THE LANDMARK HOTEL
CHARLOTTESVILLE, VIRGINIA

MINOR FAMILY HOTELS
THE LANDMARK HOTEL
OCTOBER 2008

MAIN STREET ELEVATION COMPARISON

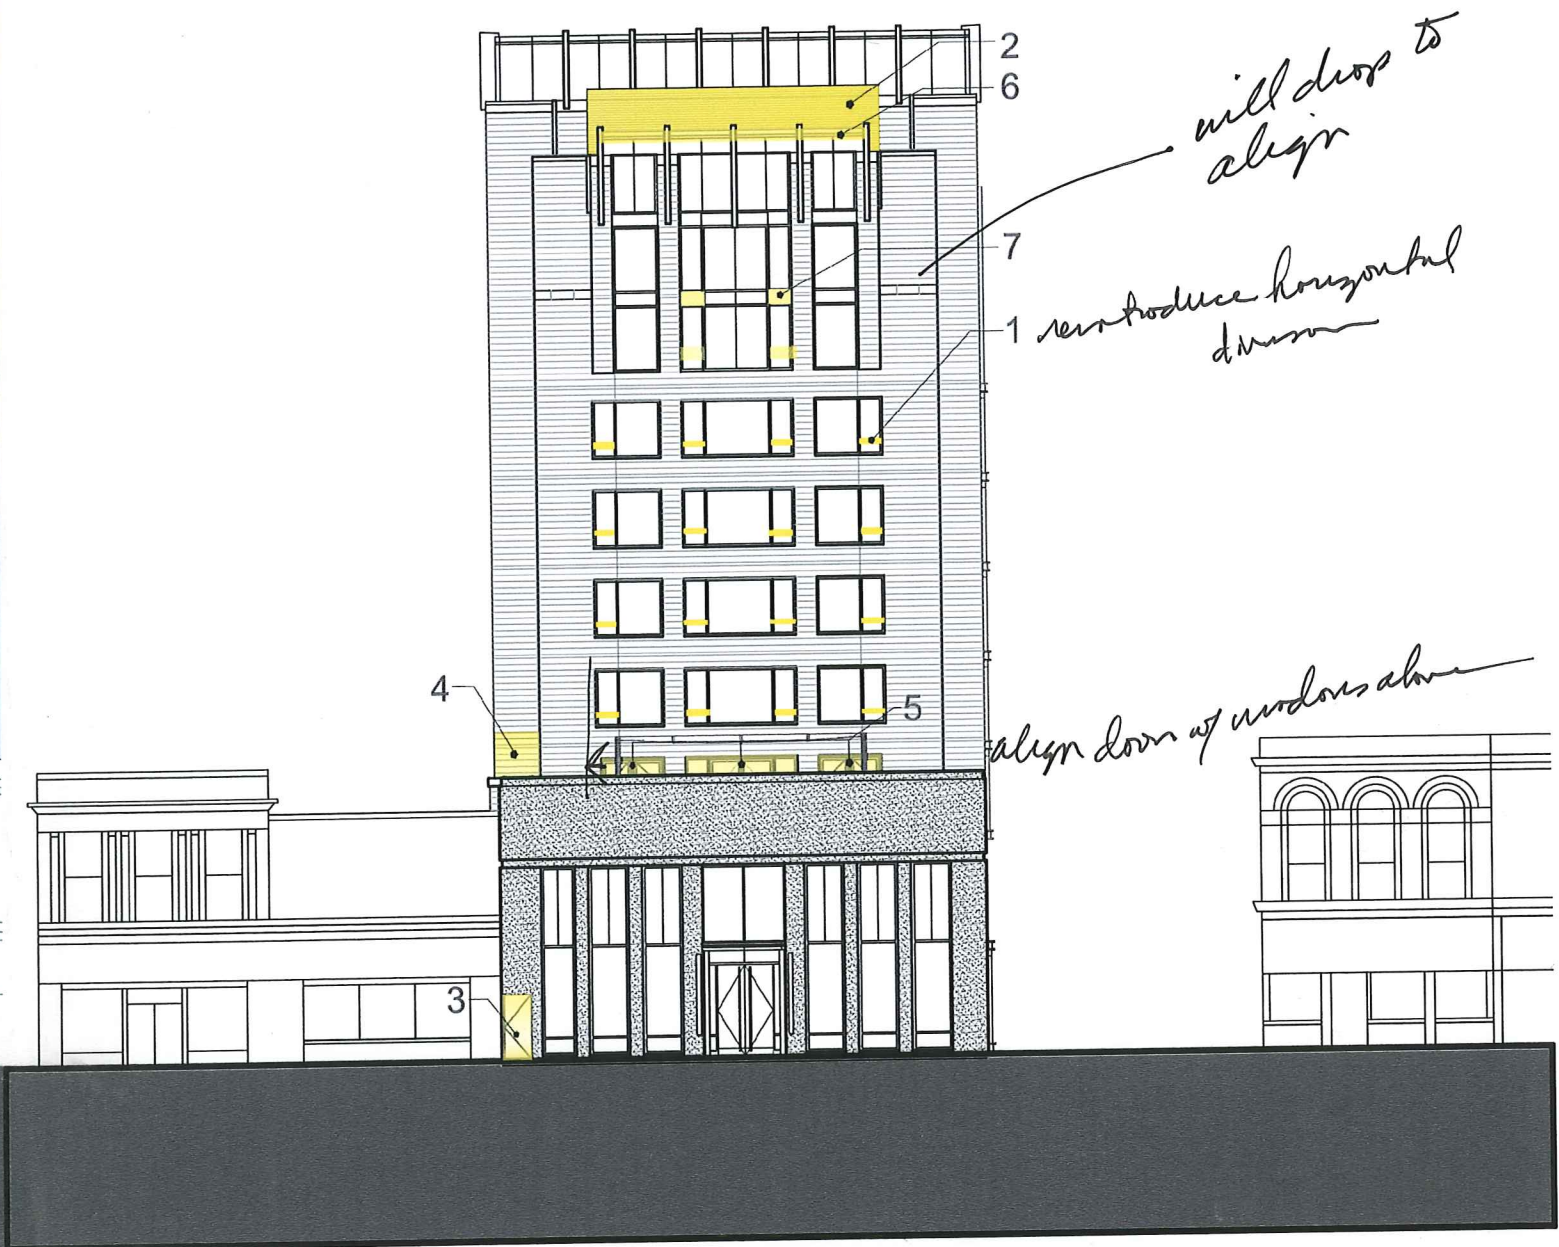
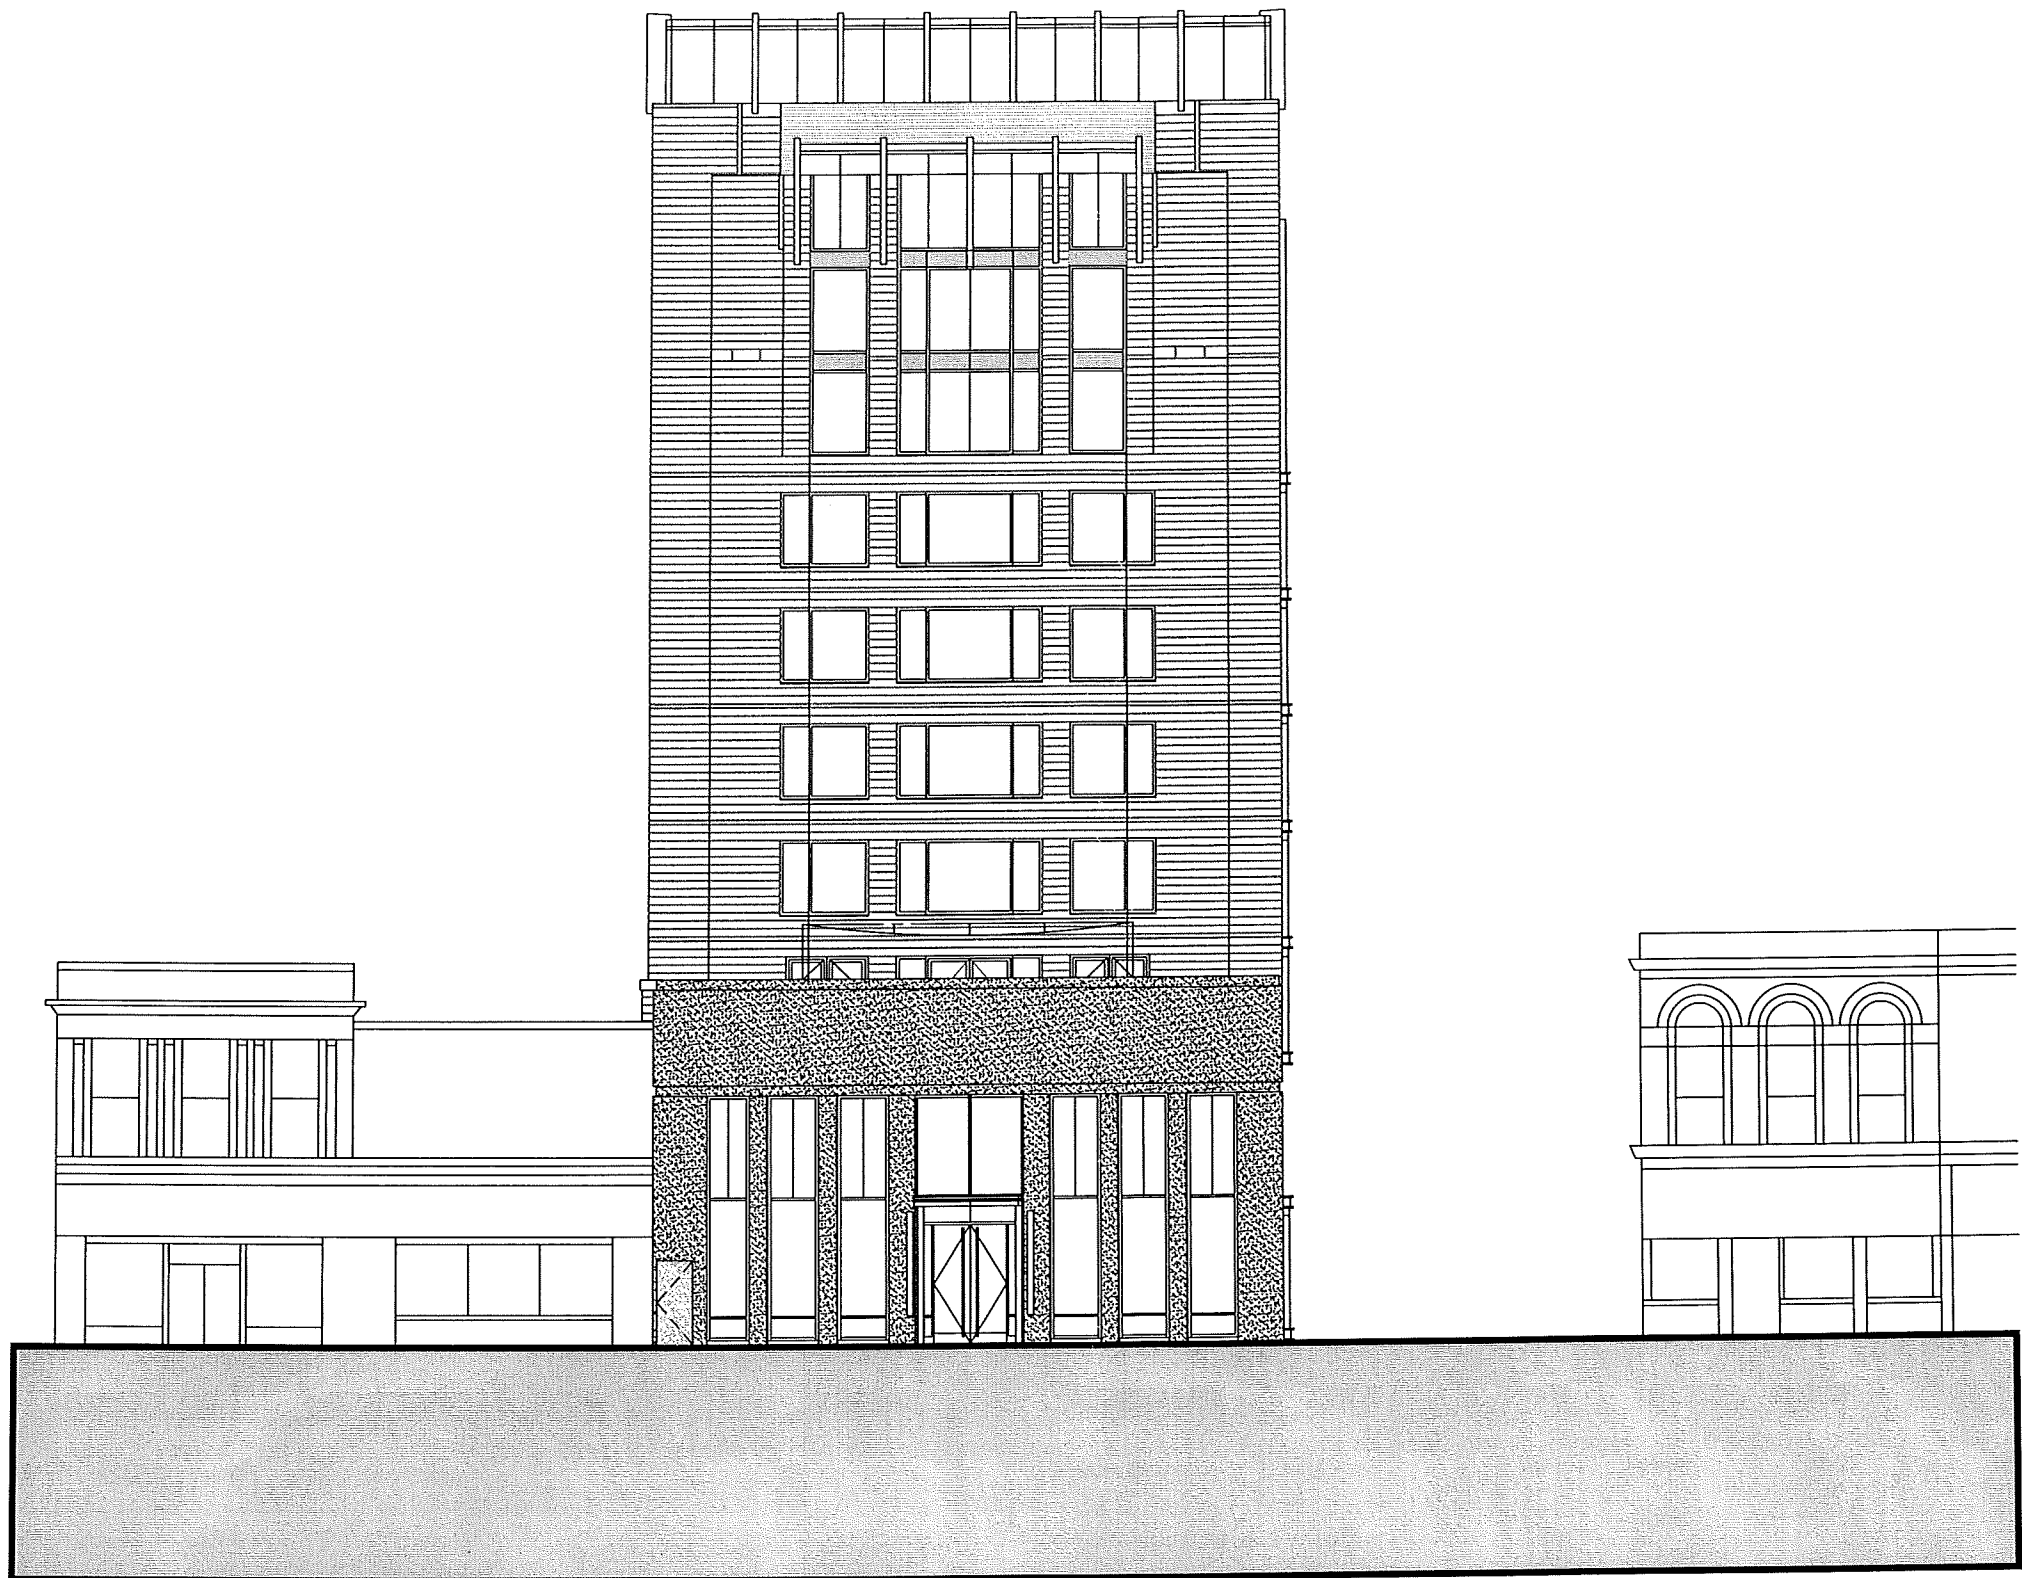
1. Butt glazed joint modification- *OK*
The guestroom windows previously had butt glazed joints shown. The joints were removed to avoid unsightly silicone sealant joints with clear glass.

2. Screen Wall- A mechanical screen wall was added through BAR approval to mask the mechanical units that service this building. *OK*
The screen wall height is adjusted to accommodate the actual mechanical units to be used.

3. Stair Egress- *OK*
A door was relocated to show as in plans.
4. Addition of pantry room bump out- *OK*
A bump out was added to accommodate the necessity for a pantry and storage for servicing the terrace.

5. Terrace Access – Doors now replace windows and a recessed portion is introduced. *align w/ windows above*
Access in and out of the terrace for guests was added in a fashion to replicate the look of above the guestroom windows above. The recess is a function for the service of the guests.

6. Addition of coping- *OK as planned*
The original design did not take into consideration constructability and this lower "light box" needs a coping to match the roof coping.

7. ~~Metal~~ panel added - *spandrel glass*
The metal panel continues across this window system for constructability purposes.

SECOND STREET ELEVATION COMPARISON

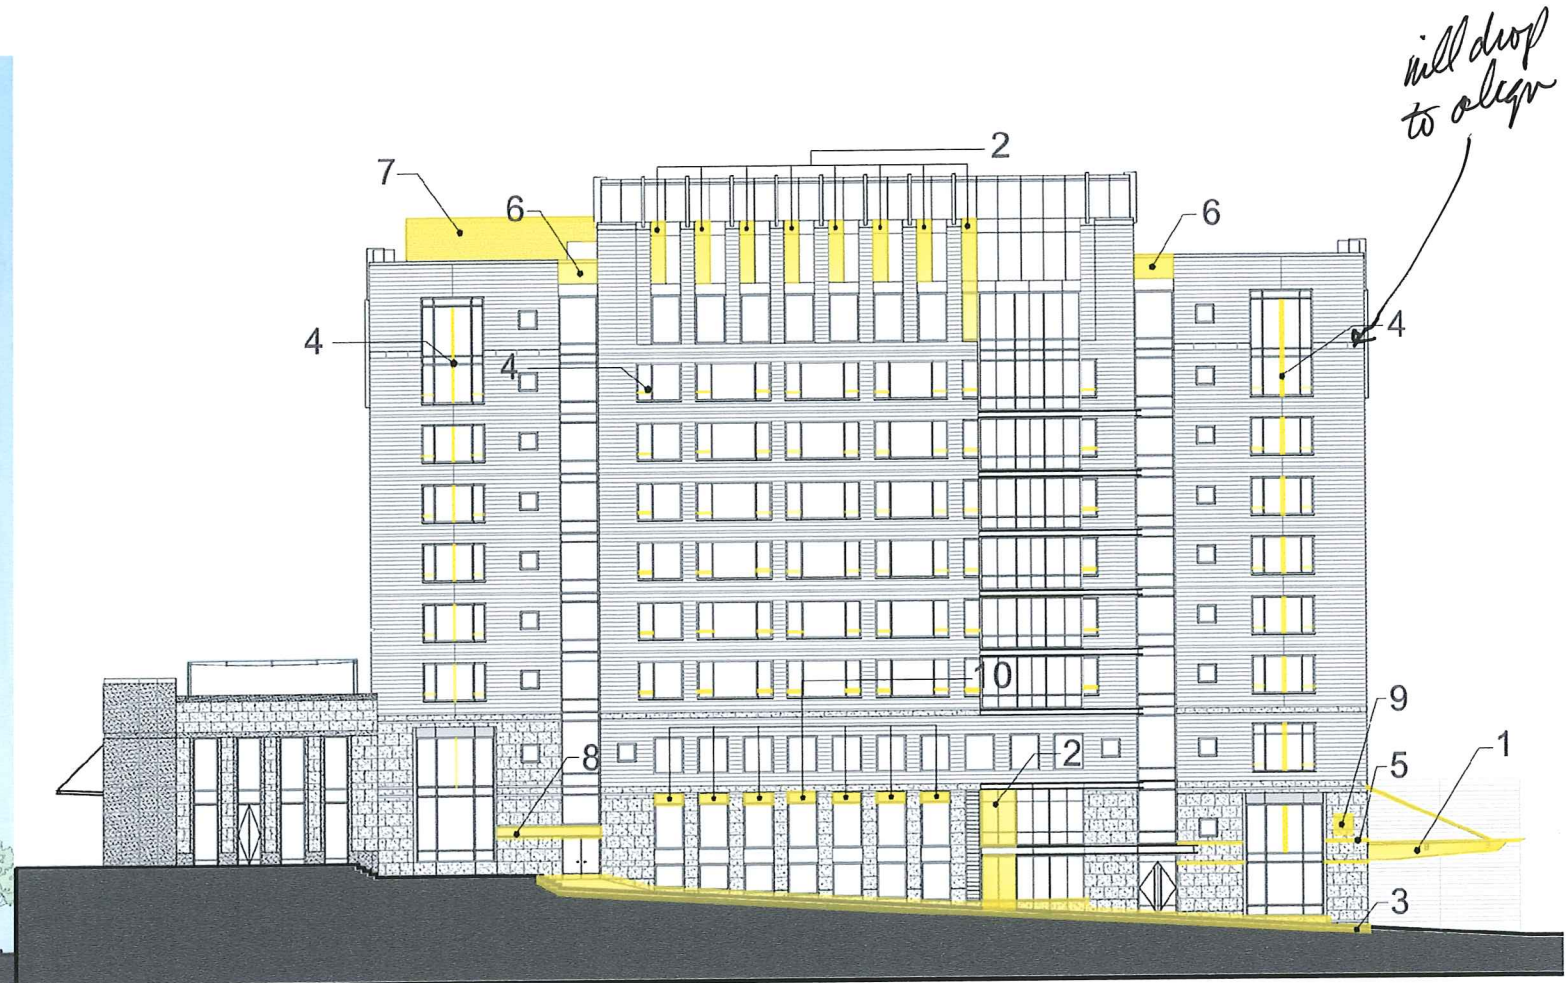
1. Canopy redesigned-

The canopy was changed and lowered through BAR approval.

2. Reduction of metal louvers- The louvers now show as glazing.

The louvers did not serve a function and it was replaced with glazing.

3. Grade change-

The grade was incorrectly shown previously and now reflects the city appointed engineer's grading levels.

4. Butt glazed joint modification-

The guestroom windows previously had butt glazed joints shown. The joints were removed to avoid unsightly silicone sealant joints with clear glass.

5. Brick Insert banding- Row directly above canopy raised to accommodate the relationship between the canopy and the façade. Bands changed from red brick to precast inserts to match adjacent precast.

Differences in materials working against each other in expansion/contraction will ultimately cause problems with cracking.

6. Addition of parapet-

Original design did not take into consideration that people would be walking on the terrace and would need a barrier for safety. change to open metal or glass

7. Screen Wall- A mechanical screen wall was added through BAR approval to mask the mechanical units that service this building.

The screen wall height is adjusted to accommodate the actual mechanical units to be used.

8. Addition of pantry room bump out-

A bump out was added to accommodate the necessity for a pantry and storage for servicing the terrace.

9. Addition of Spandrel Panel- Banquet windows with added panel above.

The spandrel panel separation will hide the floor slab and ceiling that would otherwise be visible from outside if left as originally shown.

WATER STREET ELEVATION COMPARISON

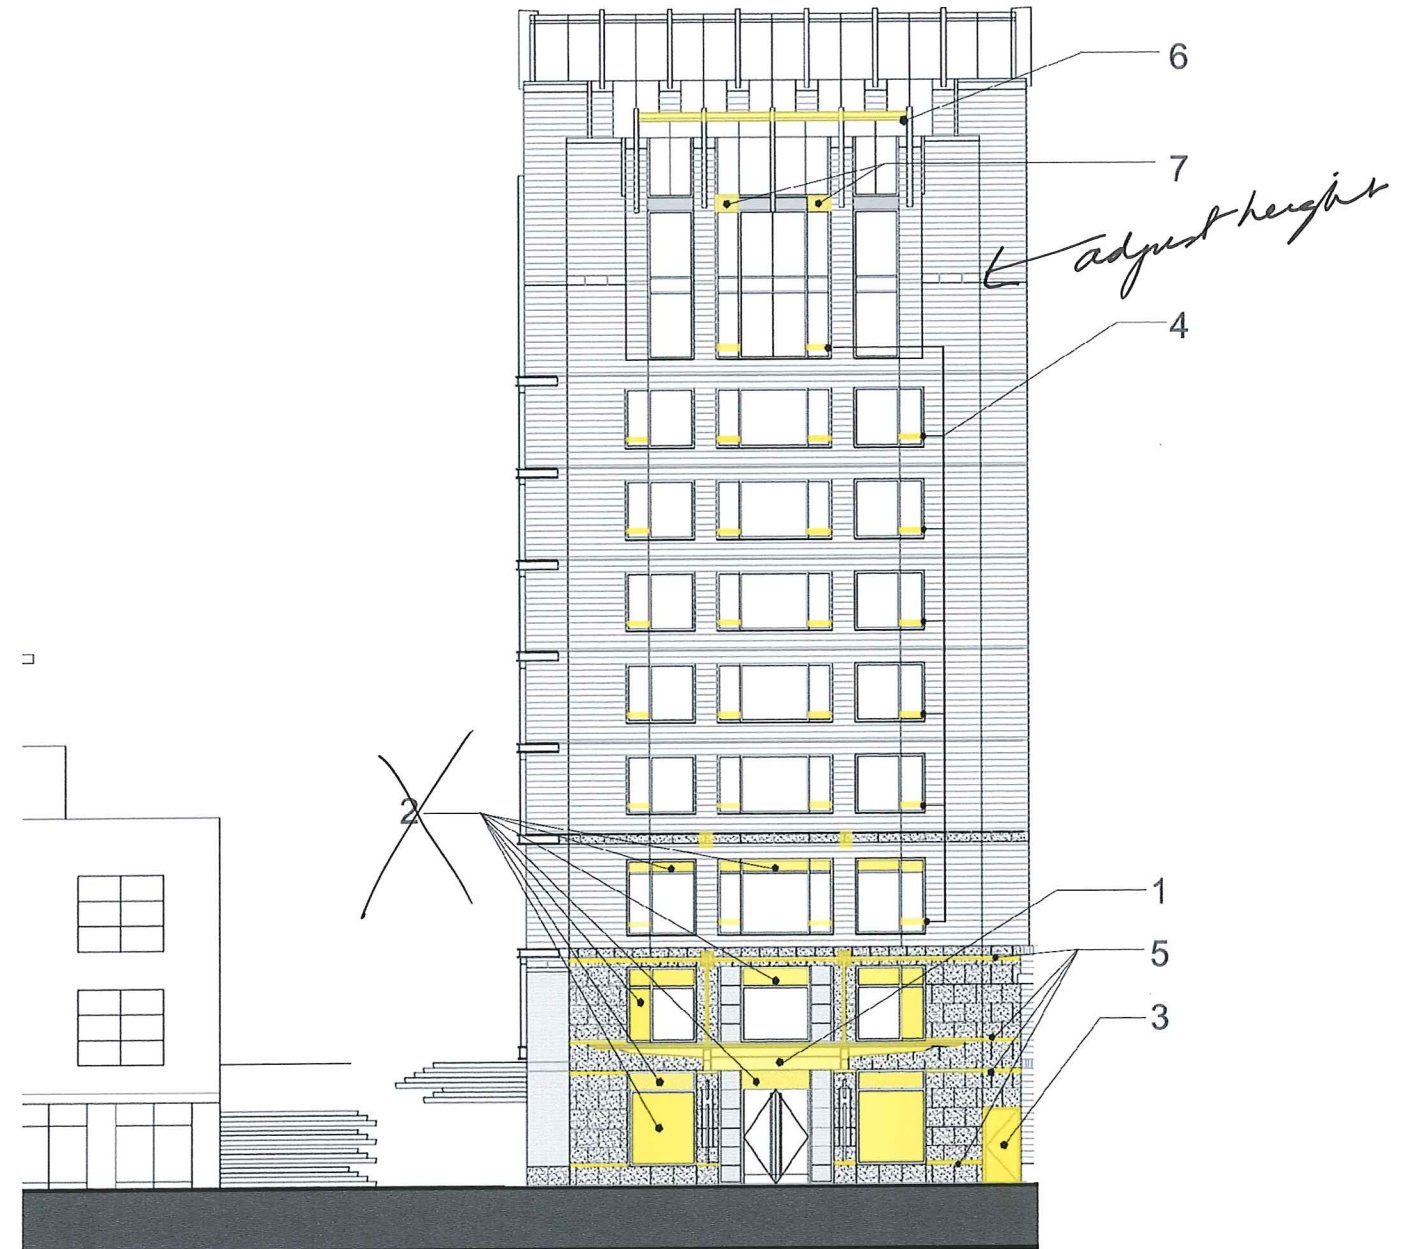
1. Canopy redesigned-

The canopy was changed and lowered through BAR approval.

2. Window modification- ~~The window systems above and below new canopy now show some portions as glazing in lieu of metal panel and vice-versa.~~

This allows more natural light into public space and guestrooms. The windows heights were adjusted to actual structural elements.

not approved

3. Stair Egress Door adjusted-

*OK
A door was relocated as per the plans.*

4. Butt glazed joint modification-

*OK
The guestroom windows previously had butt glazed joints shown. The joints were removed to avoid unsightly silicone sealant joints with clear glass.*

5. Brick Insert banding- Row directly above canopy raised to accommodate the relationship between the canopy and the façade. Bands changed from red brick to precast inserts to match adjacent precast.

Differences in materials working against each other in expansion/contraction will ultimately cause problems with cracking.

*adjust
height*

6. Addition of coping-

Original design did not take into consideration constructability and this lower "light box" that needs a coping to match the roof coping.

OK

7. Metal panel added -

The metal panel continues across this window system for constructability purposes.

Spandrel glass
